Application for Variation of an Environmental Permit

C2. Application No. of the Current Environmental Permit : AEP-532/2017

Project:  
 Mui Wo Lai Chi Yuen Extension

**ENVIRONMENTAL REVIEW  
REPORT**

Drawing Title:  
 Photomontage of Proposed Scheme

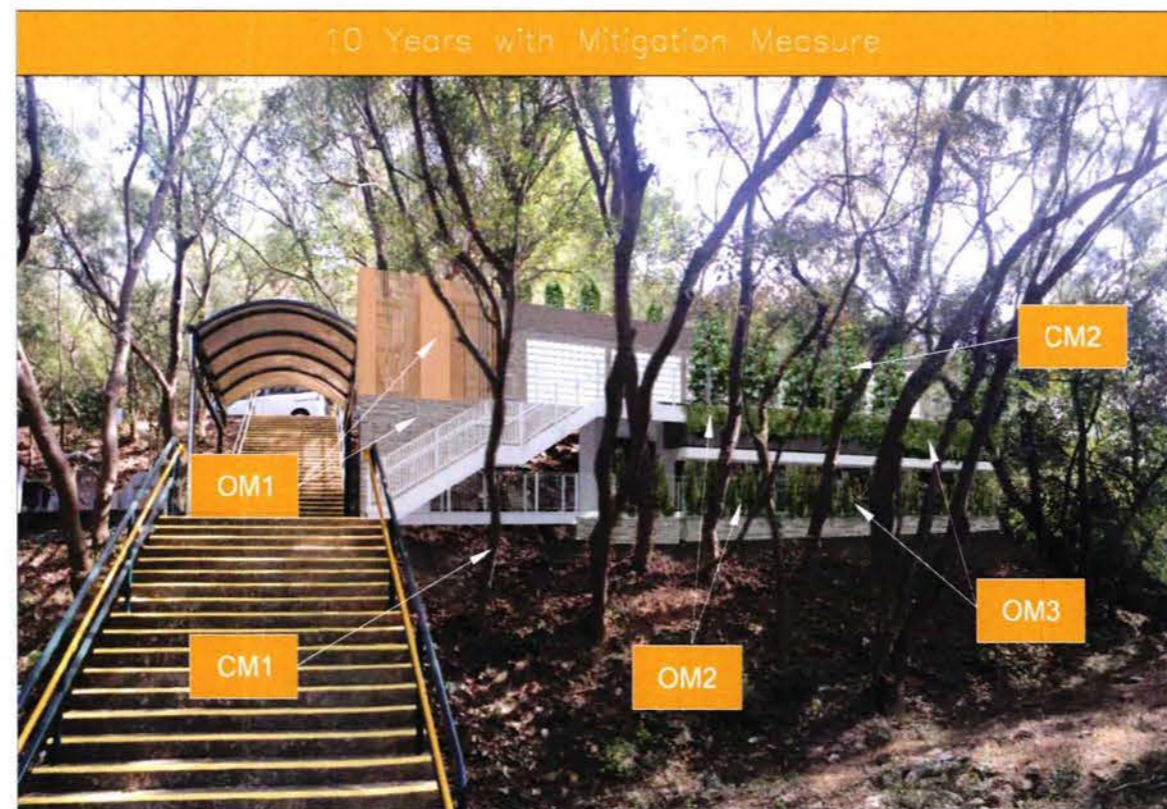
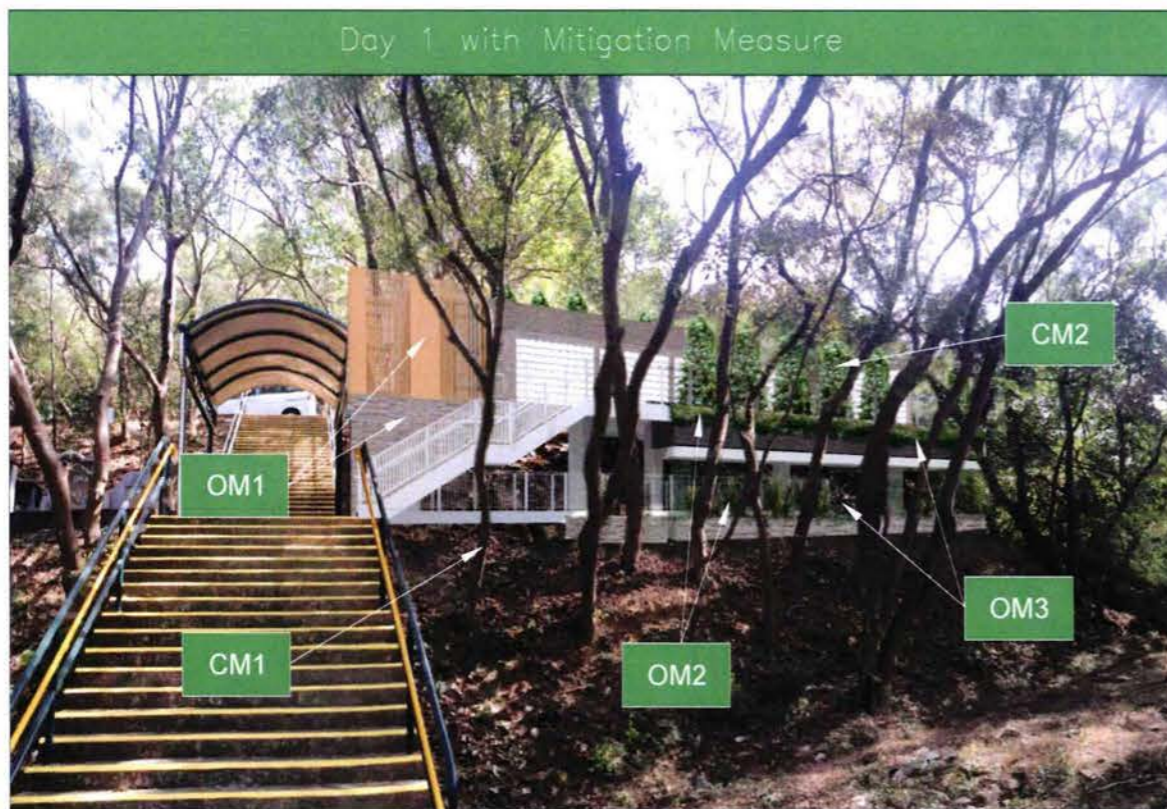
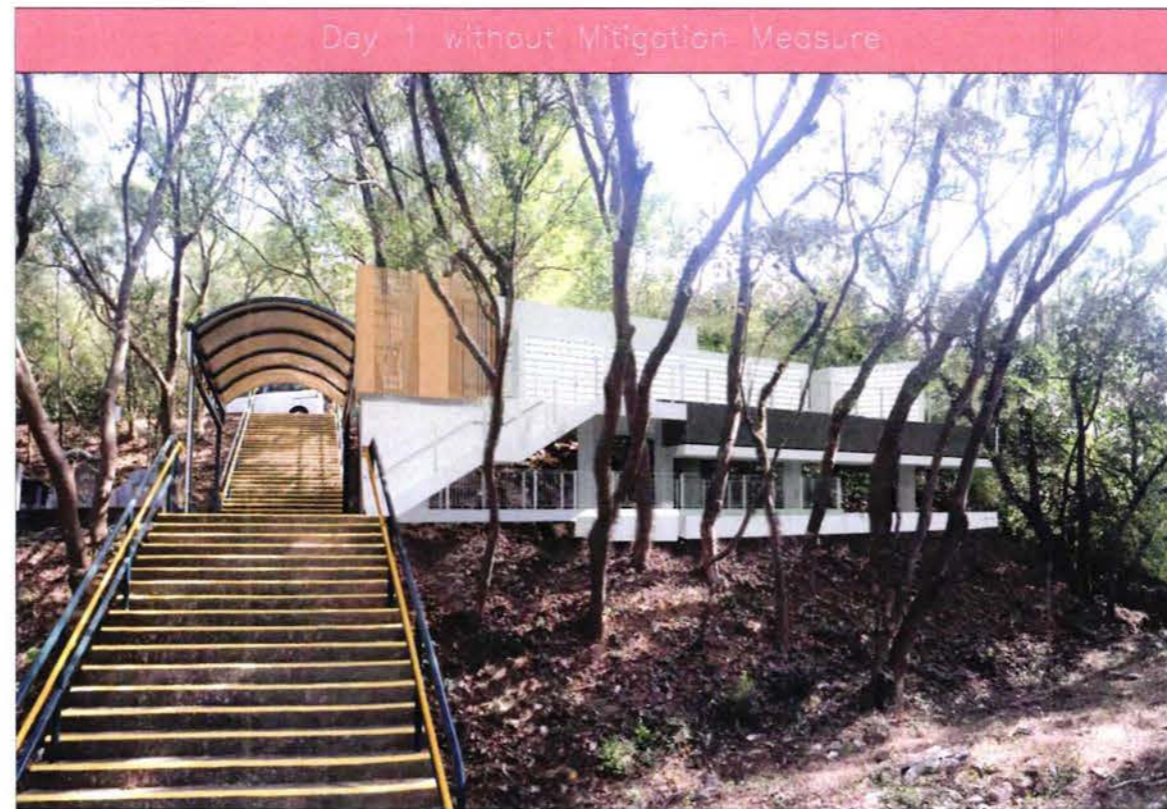
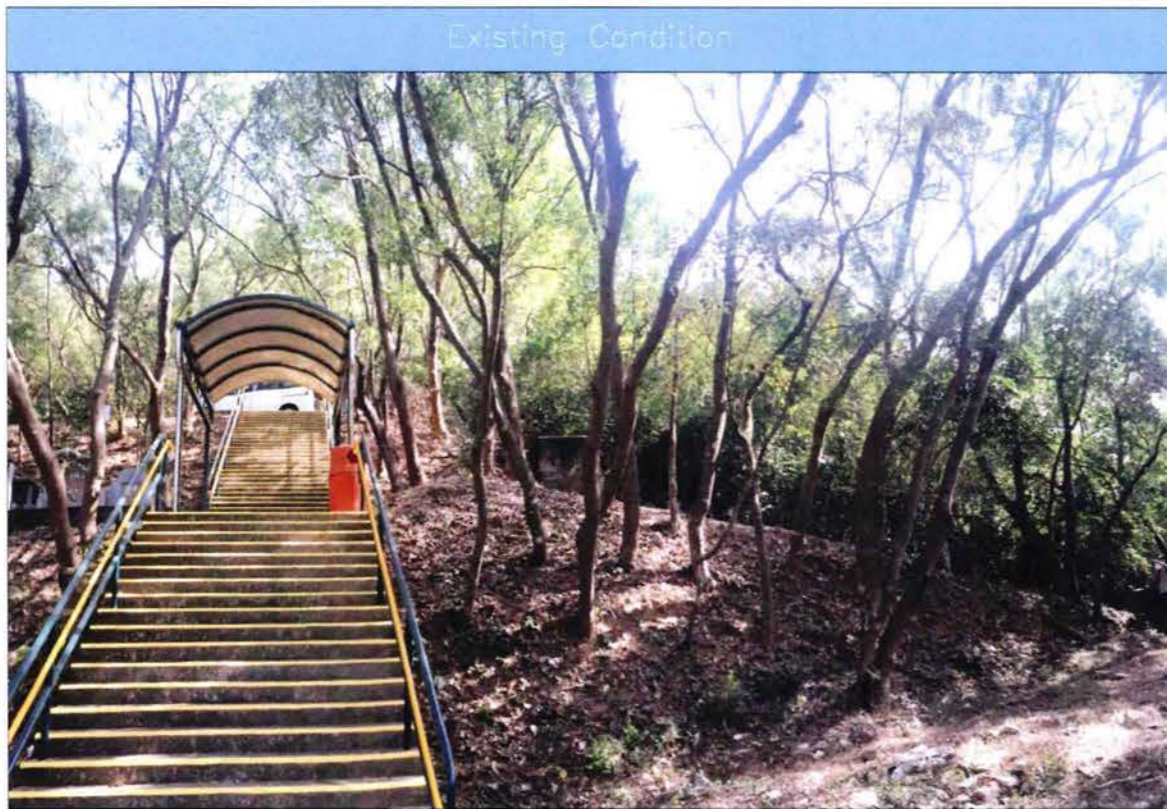
11) With the implementation of mitigation measures, which include aesthetically pleasing design of above ground structures, amenity tree and shrub planting and screen planting to soften the structural columns of the elevated platform, it is predicted that the residual visual impact on the visitors to Lai Chi Yuen Cemetery would remain slight in day 1 and year 10 of the operation. Photomontages of the EIA Scheme are extracted from Figure 9.5 of the EIA report and presented in <i>Figure 3-3</i> .	11) Mitigation measures, including aesthetically pleasing design of above ground structures, amenity tree and shrub planting and screen planting to soften the concrete structure of the elevated platform, will continue to be provided in the Proposed Scheme. It is predicted that the residual visual impact on the visitors to Lai Chi Yuen Cemetery would remain slight in day 1 and year 10 of the operation. Photomontages of the Proposed Scheme are presented in <i>Figure 3-4</i> .
